DEPARTMENT OF TRANSPORTATION**National Highway Traffic Safety Administration****49 CFR Part 571****[Docket No. NHTSA-03-15343]****RIN 2127-AJ09****Federal Motor Vehicle Safety Standards; Occupant Crash Protection**

ACTION: Correcting amendment.

SUMMARY: This rule corrects errors in Figures 6a, 6b, 7, 8, and 9 of Federal Motor Vehicle Safety Standard No. 208, *Occupant crash protection* (FMVSS No. 208). These figures were added to the standard in two separate and unrelated rulemakings. They provide instructions

Figure 6a. Sun Visor Label Visible when Visor is in Down Position.

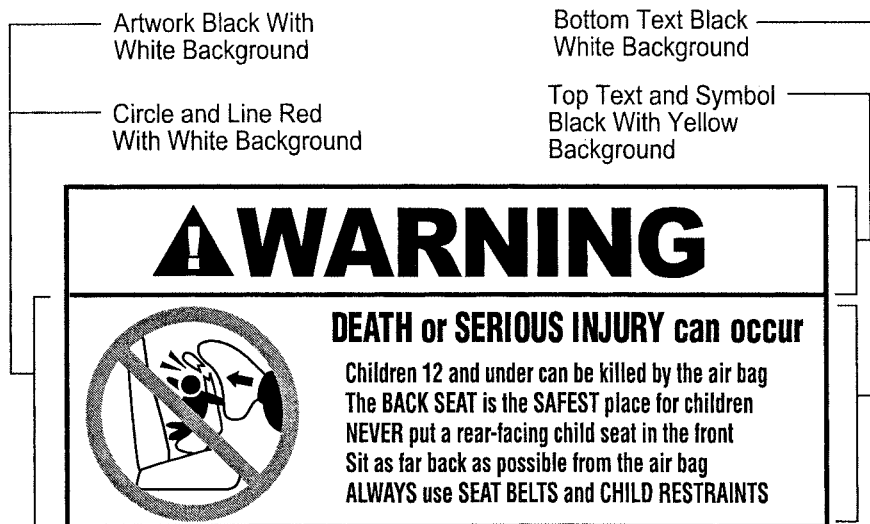
There are two instructions in Figures 6a and 6b and one instruction in Figure 7 that are not restated in any requirements in the regulatory text. One is a format/color instruction about a black outline. The other is a color instruction about using red for bullets in the message area. Figure 7 contains only the format/color instruction about the black outline.

Accordingly, we are amending Figures 6a, 6b and 7 of FMVSS No. 208 to remove the reference to a black outline. We are also amending Figures 6a and 6b to delete the reference to red bullets. We are likewise amending Figures 8 and 9. Figure 8 was based, in large part, on Figures 6a and 6b. Figure 9 was based on Figure 7. When the advance air bag final rule incorporating Figures 8 and 9 was published (65 FR 30680, Docket No. NHTSA-00-7013, May 12, 2000), the agency had already indicated in the earlier rollover label rulemaking that it did not believe the outline in Figures 6a, 6b and 7 were required. The instruction should not have been included in Figures 8 and 9, since we made no findings in that rulemaking that our previous position was incorrect.
